**DESIGN REVIEW BOARD MEETING  
PACKAGE**

*November 29, 2021 (Monday), 12:00pm*

<b>TITLE:</b>  <p style="text-align: center;"><b>DESIGN REVIEW</b></p> <p style="text-align: center;"><b>FILE: DESIGN-2021-29-November 6a</b></p> <p style="text-align: center;"><b>55 CHESTNUT STREET (PID #361527)</b></p> <p style="text-align: center;"><b>OWNER: 11126105 CANADA INC.</b></p>		
<b>MEETING DATE:</b>  Nov 29th, 2021		<b>Page 1 of 4</b>
<b>DEPARTMENT:</b>  Planning & Heritage	<b>ATTACHMENTS:</b>  A. September 20, 2021, Design Review Board Report B. Applicants Response to Design Deficiencies C. Project Deficiencies highlighted in June 2021	
<b>SITE INFORMATION:</b>  <b>Context:</b> Chestnut Street between University Avenue & Queen Street  <b>Ward No:</b> 4 – Spring Park  <b>Existing Land Use:</b> 27-Unit Apartment Dwelling awaiting Occupancy  <b>Official Plan:</b> Medium Density Residential  <b>Zoning:</b> Medium Density Residential (R-3) Zone		
<b>PREVIOUS APPLICATIONS:</b>  Design Review approval was granted on October 30, 2018 with revisions on February 20, 2020.  Design Review approval was granted on September 4, 2020 for a revised design.  Design Review meeting September 2021 seeking ap

1 EAST ELEVATION

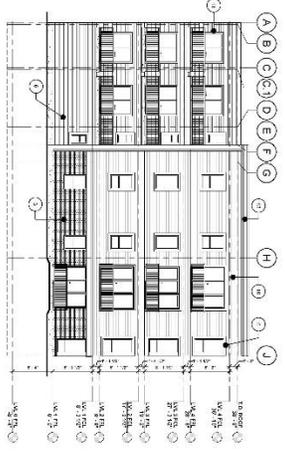
- ***Siding Orientation*** – The front-facing vinyl siding and side-facing metal siding have been installed vertically, as opposed to horizontally as per the revised elevations plan received August 25, 2020.

- ***Side Façade Design*** – The side façade does not match the design specifications in the revised elevations plan received August 25, 2020. The brick and vinyl front façade and black metal bands are shown to wrap around the side, extending approximately 44 ft to the step-back in the building footprint, then be accented in the black metal bands at the step-back. What was constructed does not match: on both sides the brick and vinyl front façade wraps less than half the distance proposed by the revised plan. The remaining side façade meant to be vinyl, brick and metal bands to match the front, uses the rear siding instead. These alterations did not receive an amendment to the Development Agreement nor approval by the Design Review Board.

- ***Balcony Design*** – The six balconies on the western side of the development, and the four balconies on the eastern side, have been built using wooden support posts as opposed to

cantilevers as per the revised elevations plan received August 25, 2020. The wood support post balconies do not match the balconies on the front of the building (which use cantilevers).
